Eck 10th Addition

RE: SUB 2001-81-- Final Plat of Eck Tenth Addition

REVISED STAFF REPORT

CASE NUMBER: SUB 2001-81 -- ECK TENTH ADDITION

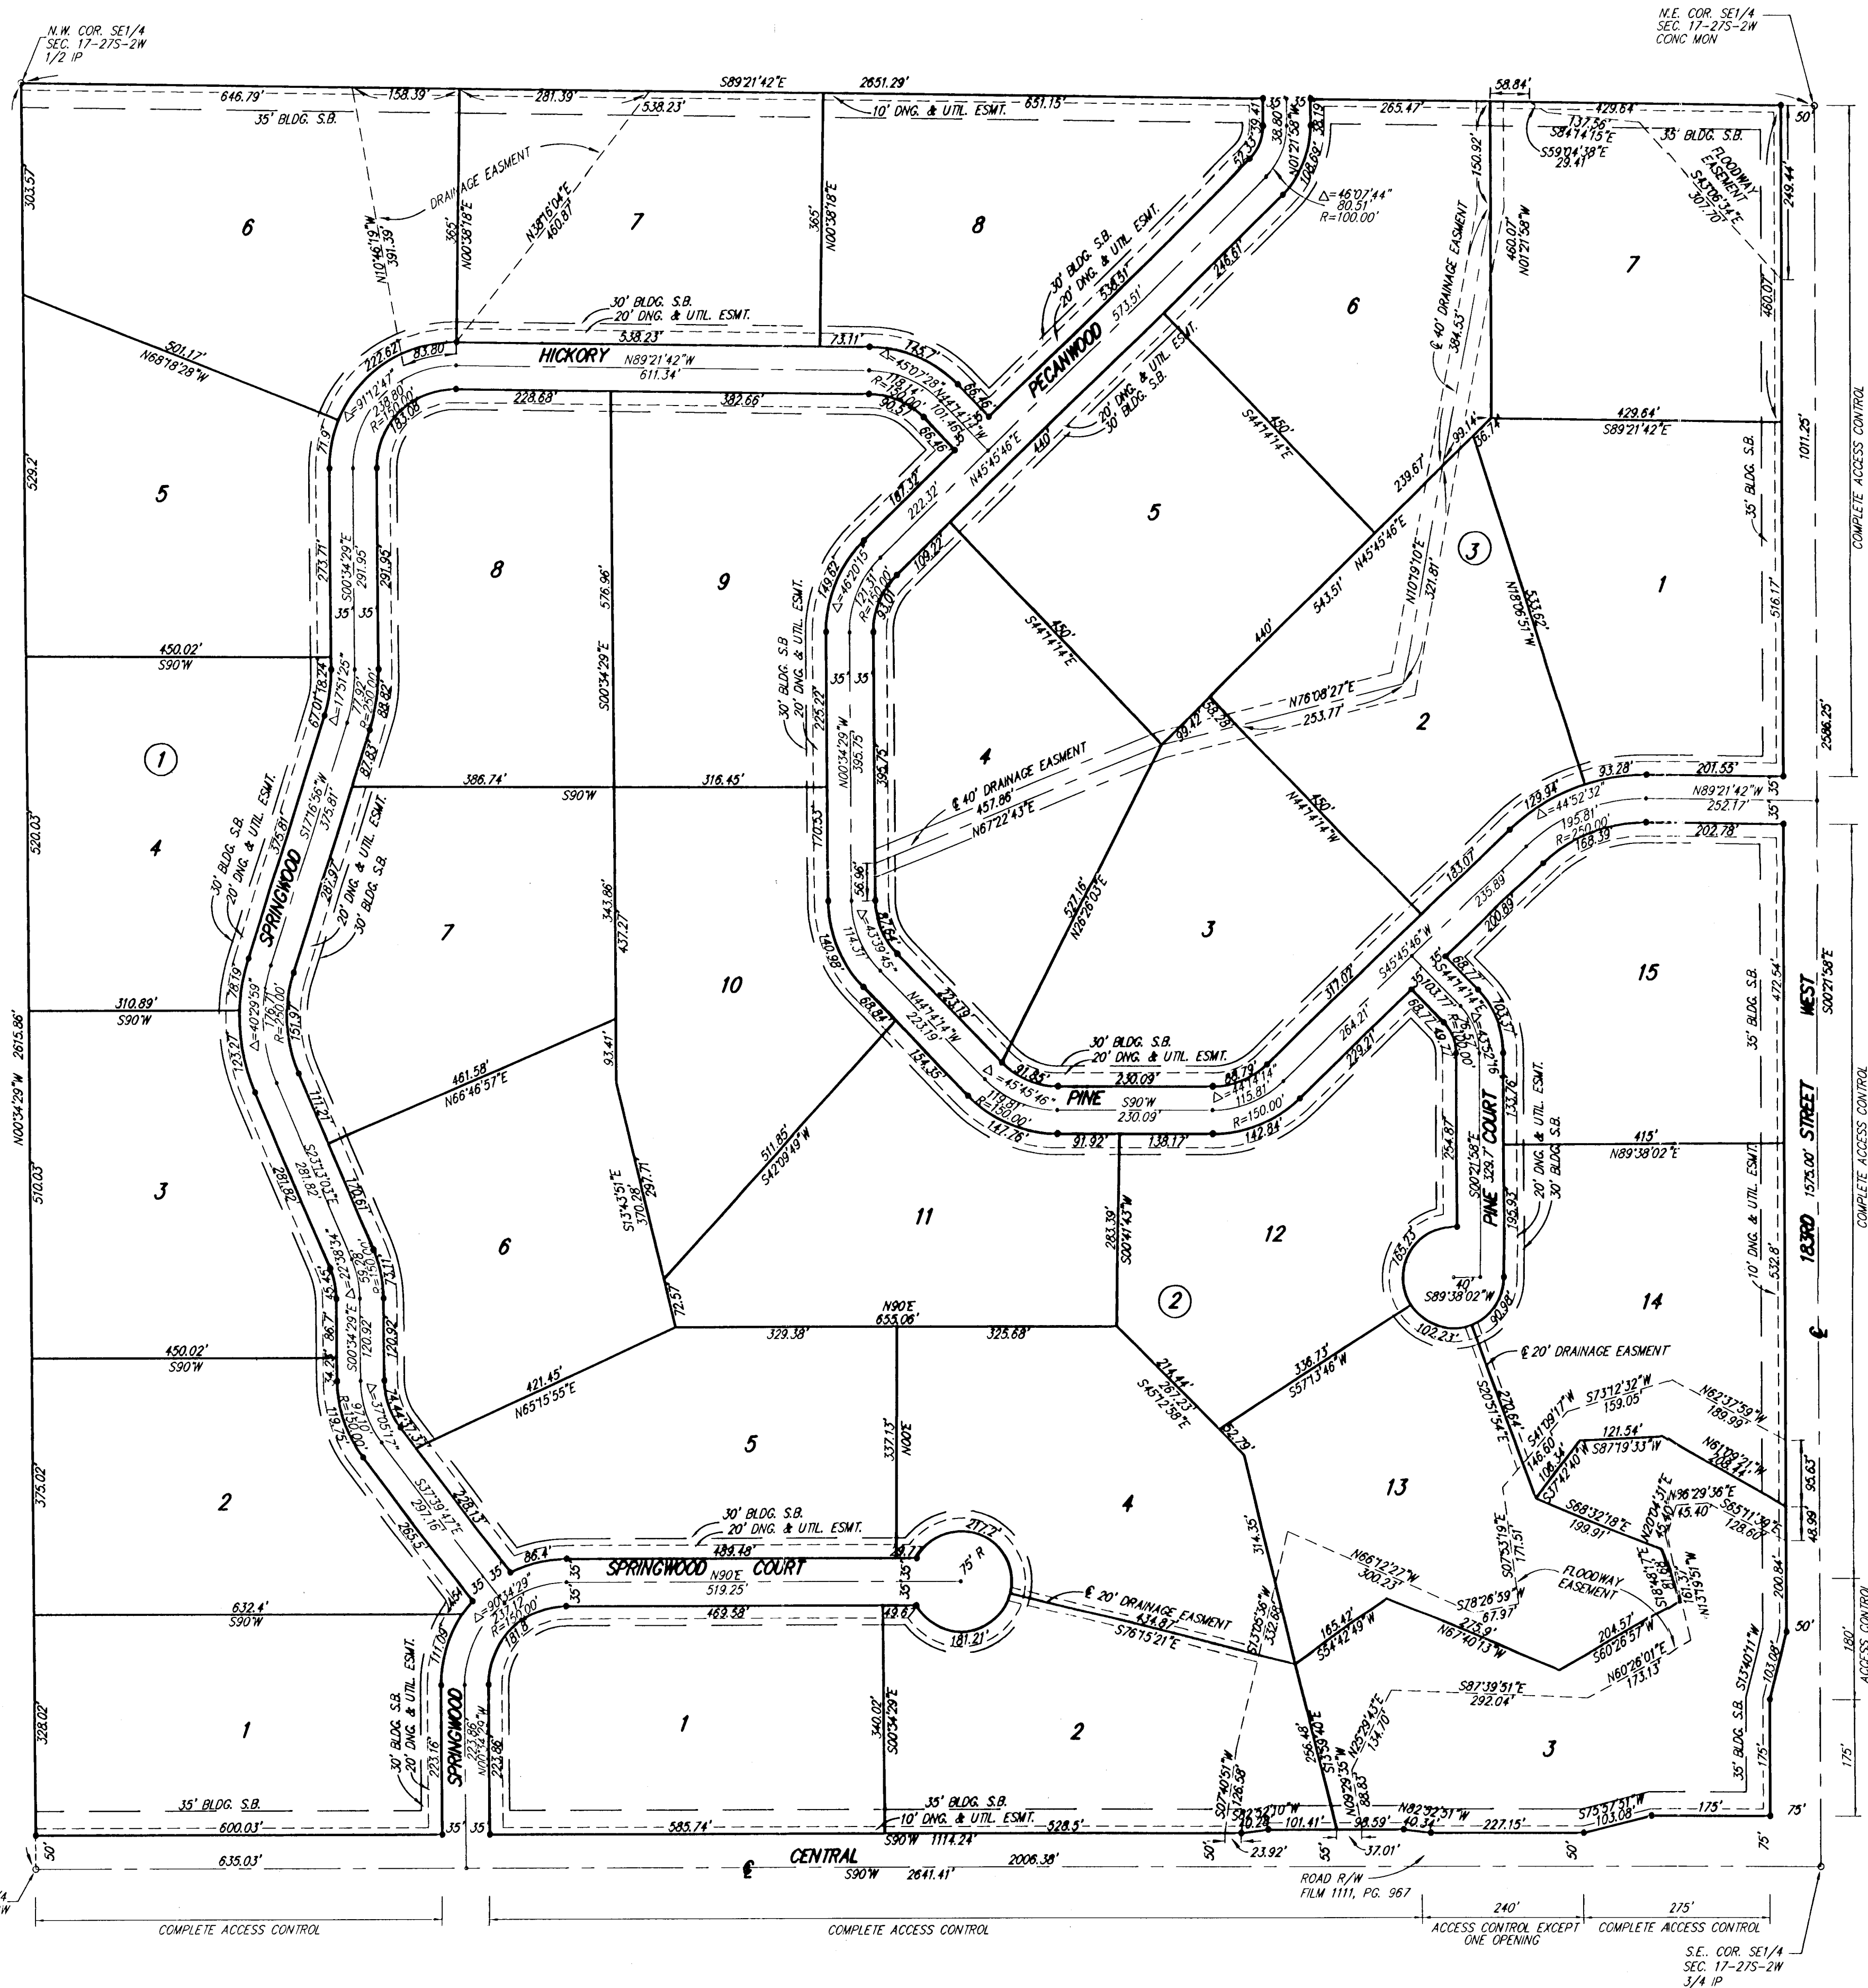
- A. Since sanitary sewer is unavailable to serve this property, the applicant shall contact the Environmental Health Division of the Health Department to find out what tests may be necessary and what standards are to be met for approval of on-site sewerage facilities and water wells. A memorandum shall be obtained specifying approval. *A plot plan is needed for Lots 3, Block 2, and Lot 6, Block 1 to verify buildable area.*

- E. County Engineering needs to comment on the status of the applicant's drainage plan. *Floodway reserve boundaries need to be reviewed. Adjustments to floodway reserves may be required after review of the drainage plan. Minimum pads may be required. Development on Lot 6, Block 1, and Lots 2,3,4,13,14, Block 2, needs to be restricted prior to a letter of Map Revision from FEMA. Drainage easements may need to be increased. A Master Lot Grading Plan is needed.*

- F. County Engineering has required complete access control to 183^d West for Lot 7, Block 3; access may be obtained from Willow Creek Drive.

- I. The County Fire Department/GIS needs to comment on the plat's street names. GIS has required Autumn Drive be revised to Springwood; extending from the south line of the plat to include the frontage of Lot 5, Block 1. Autumn Drive Ct shall be revised to Springwood Ct. Pecanwood Road shall be revised to Pecanwood extending from the north line of the plat to include the frontage of Lot 10, Block 2. Pine Road shall be revised to Pine.

- GIS has requested the removal of the street names denoted on the abutting property to the north.
- J. Lot 13, Block 2 does not meet the 200-ft lot width requirement which is measured at the building setback line. The lot also does not meet the 100-ft lot frontage requirement. A modification will need to be approved. The Subdivision Committee has approved a modification.

- M. The floodway reserve near the southeast corner of plat needs located with respect to property lines.
- N. On the final plat tracing, the MAPC signature block needs to reference "J.D. Michaelis, Chair".

The requested access controls have been platted.
